**RESOLUTION HOLDING PUBLIC HEARING ON APPEAL BY EYCHANER  
PROPERTIES, INC. OF THE DENIAL OF A SITE PLAN FOR A PROPOSED  
OFF-STREET PARKING LOT AT 444 SOUTHWEST 5<sup>TH</sup> STREET**

RE: 444 SW 5<sup>th</sup> Parking Lot

We have reviewed the first (1<sup>st</sup>) submittal of the site plan for the 444 SW 5<sup>th</sup> Parking Lot in Des Moines, and have determined that the following conditions must be satisfied before plan approval can be granted.

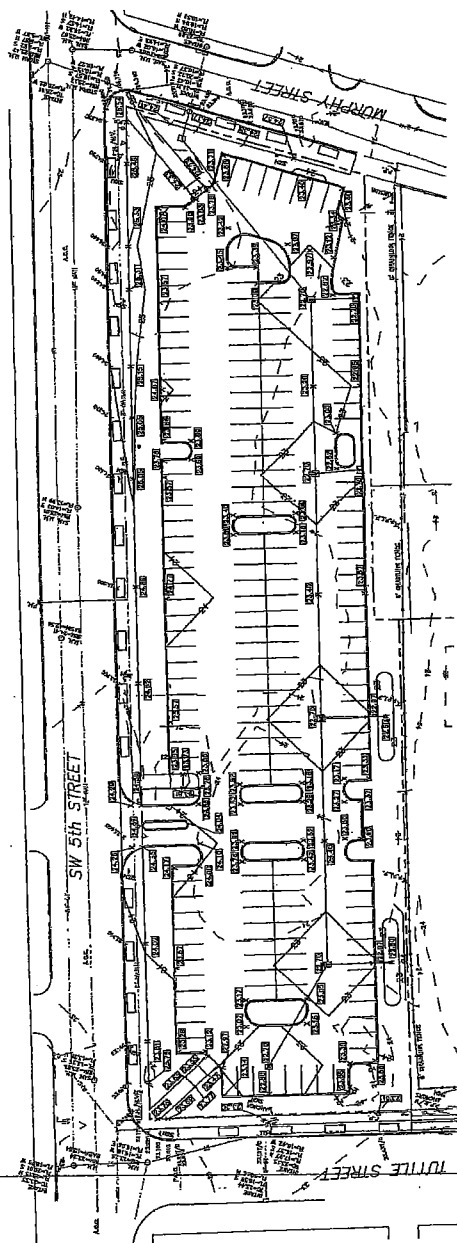
2. Show bearings and distances of the property lines on the Geometric Plan.
3. Label the City of Des Moines benchmark as ID# 150.
4. Note that the storm sewer connection to existing manhole shall be core drilled.

5. If desired, the Utility Plan may be omitted as it is similar to the SWMF Plan.
6. The structure #2 detail should show or include a note that the 15" storm sewer from the west shall enter the manhole on the upstream side of the orifice plate.

7. The orifice dimensions should be labeled as either "diameter" or "squared" in the detail to avoid confusion. 6.1' should read 6.1".
8. Document the dissipation/ permeability capabilities of the native soils on site in the stormwater narrative.

10. Show and specify the type of fabric on the top and sides of the proposed recharge pit.
11. The impacted area of the project exceeds one acre and therefore the owner/developer must apply for a NPDES General Permit No. 2 through the IDNR. Additionally, submit the SWPPP and a copy of the NPDES documents to the City of Des Moines for review and acceptance.
12. A Grading Permit application is are required. You may download the form here: <http://www.dmgov.org/Departments/CommunityDevelopment/PDF/Grading%20Permit%20Appl%20v2014.pdf>
13. Add the following information to the Stormwater Management Facilities Plan:
  - A. Clearly list the following: WQv volume; 100-year storm volume, basin bottom elevation, WQv water surface elevation, and the design 100-year storm water surface elevation.
  - B. A listing of long-term maintenance requirements, verbatim, as follows:

### ORNAMENTAL FENCE DETAIL

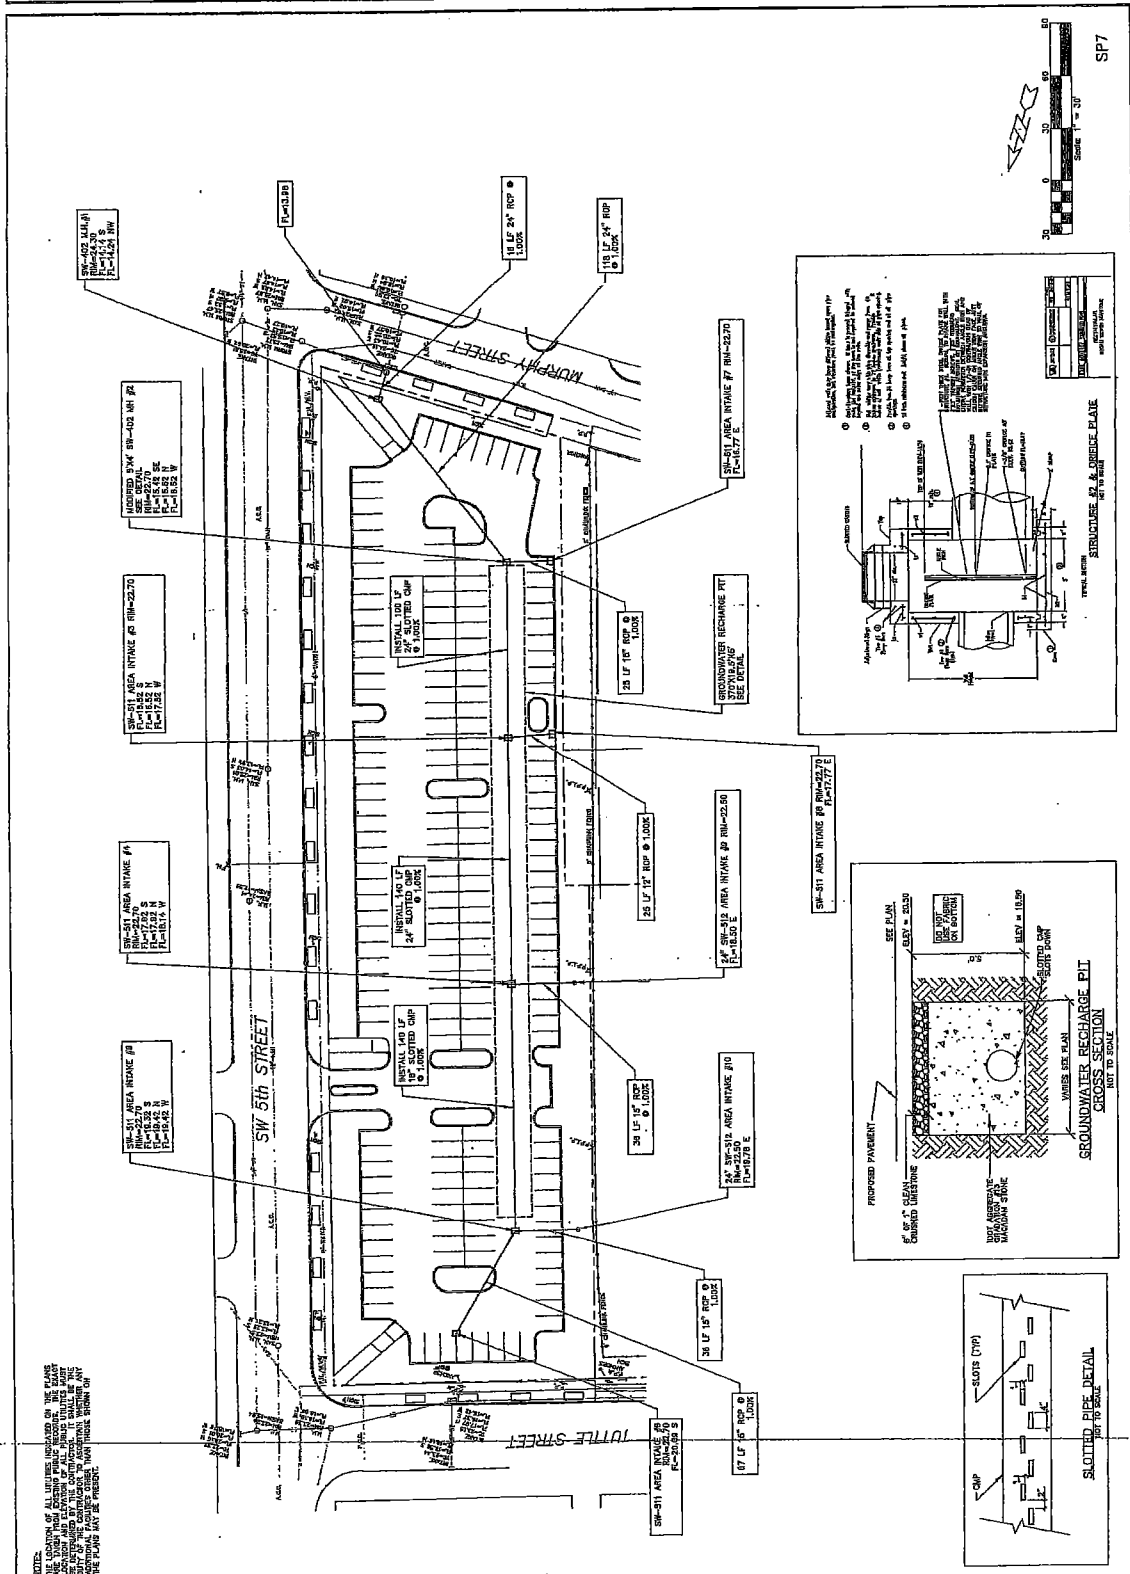
17. The ornamental fence along the parking perimeter needs to be moved so that plant materials are first visible from the street side and then the fence.
